PureThermal OpenMV Hardware Errata

June 14, 2022 - Version 1.0

Figure 1: This is damage caused by removing the battery connector without special care to avoid damage.

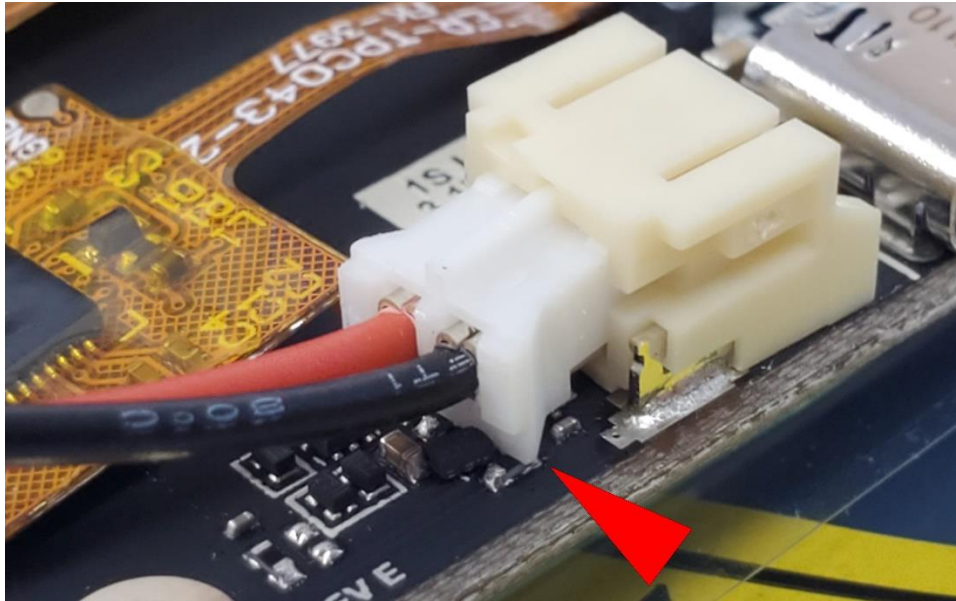
There are components beneath the battery connector which can come in contact with the battery cable end. Removing the cable can take components off the board with it.

It is recommended to remove the protruding wedge from the battery cable connector before use. This will prevent risk of damage.

Figure 3: C96 and C97 are circled in this schematic view.

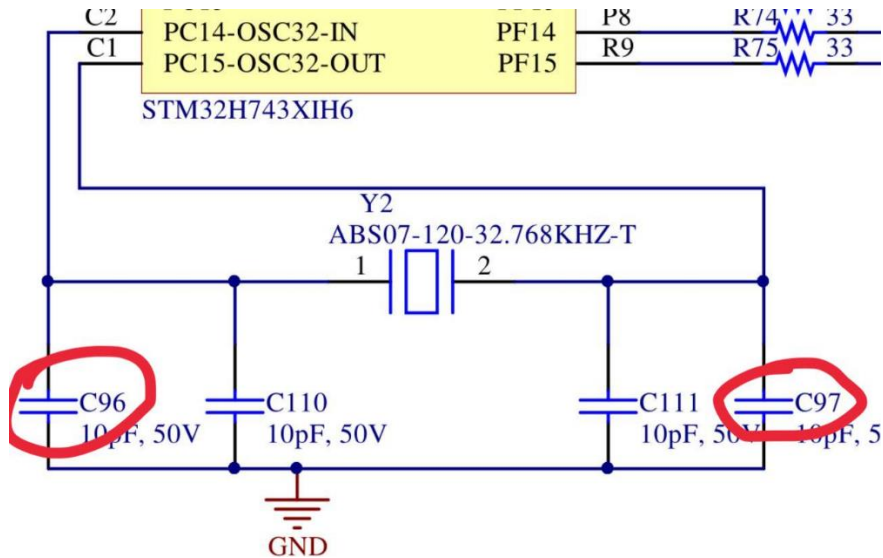
The load capacitance on the Y2 crystal is too high. Removing C96 and C97 can restore functionality to the RTC, but results may vary. These capacitors are already removed on some boards.
